NN ARBOR HISTORIC DISTRICT COMMISSION

Staff Report

ADDRESS:	541 Third Street, Application Number HDC21-293
----------	--

DISTRICT: Old West Side Historic District

Current Driveway Conditions:

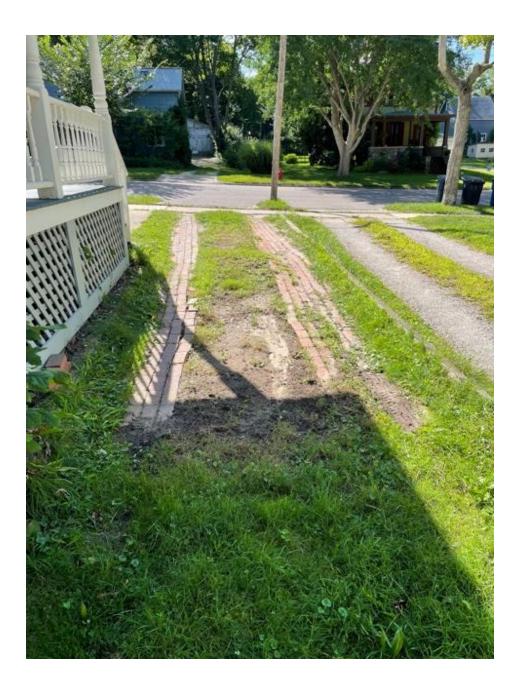
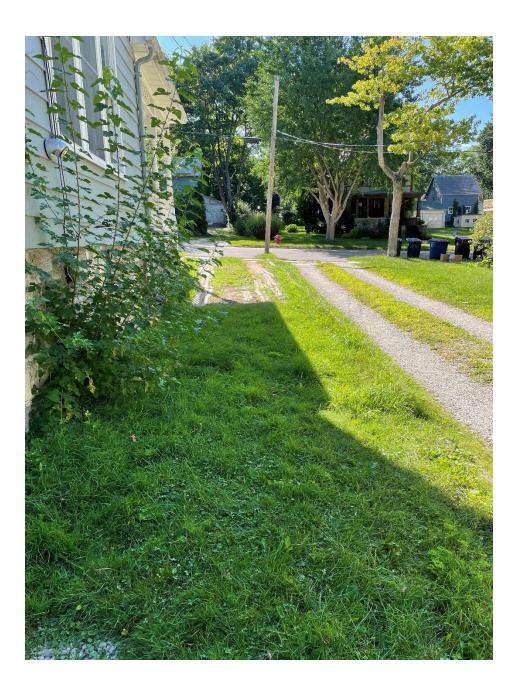
- 3. I still strongly recommend including a planting strip if you have room. The 9" concrete strip at the foundation isn't typical, and weeds alone aren't going to harm your historic block foundation. Could you maintain a grass strip along the front porch as a visual buffer, then expand it to reach the house? That might be found more appropriate than concrete all the way up to the porch.

2. I have attached a new drawing showing more of the lot. I have traced from the mortgage survey and this drawing is drawn to scale. I tried to limit the words on the drawing to make it less busy. I put in the corner but for your information as well, 1/4" equals 2ft in the drawing. The carriage house will be 40ft from the proposed end of the driveway.
3. That should be fine that we could continue the grass strip from the front walk back until the end of the front porch and then pour the concrete all the way up the house in the back.

Current fences:

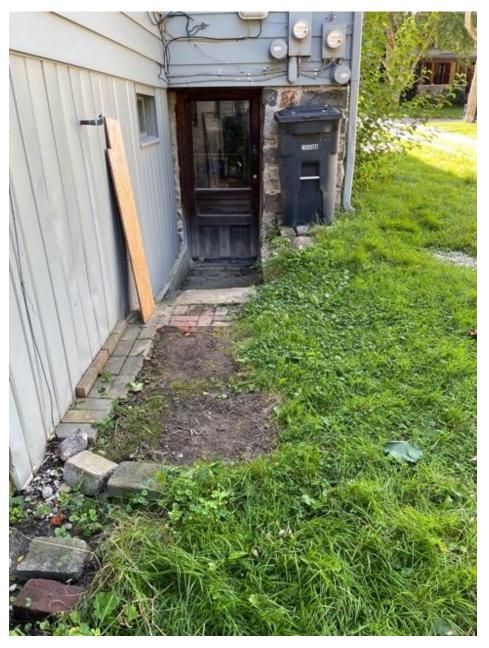
- 5. My concern about a 5' fence across the back of the driveway is that it will block the barn from view and totally box in a backyard that has historically been fairly visible from the street. I realize that you have a big dog and want him boxed in! On the south side of the house, please add to your drawing the location of the large tree that looks like it's near the path of the new N/S fence. That fence runs off the page does it join up to an existing fence along the south property line, or will that be a new fence also?

5. I understand your concerns with the fence. The top foot will be open with only small slats as seen in the picture so only the bottom 4 ft will be lost from view. We do have a temporary fence in place now that is 4ft tall and from the grade of the driveway, the entire carriage house can still be seen from the street so I do not think the new fence will change the view that much. I have included the carriage house in the updated drawing attached. I have shown the location of the trees on the south side of the yard and there is space between 2 of the trees to place a fence. The fence will meet up with a current fence on the south property line. This is also shown in the new drawing that I have attached. 6. The front walk will be the same size as the current walk but we will move it 4" to the right (south) in order for the walk to be centered on the front steps. The grass strip will be 2ft between the driveway and new front walk with the 4" move (currently the grass is 20" wide). Yes, the pavers will also have the black edging like in the photo.

Front walk current conditions:

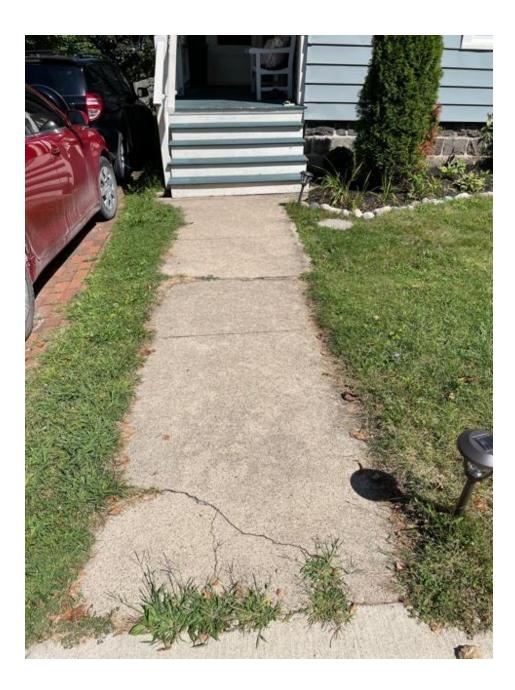
- 6. Will the front walk match the extent of the existing concrete walk, or is it getting wider? How wide is the strip of grass between the new front walk and driveway? Would the pavers you want to use have brick edging like in the photo?
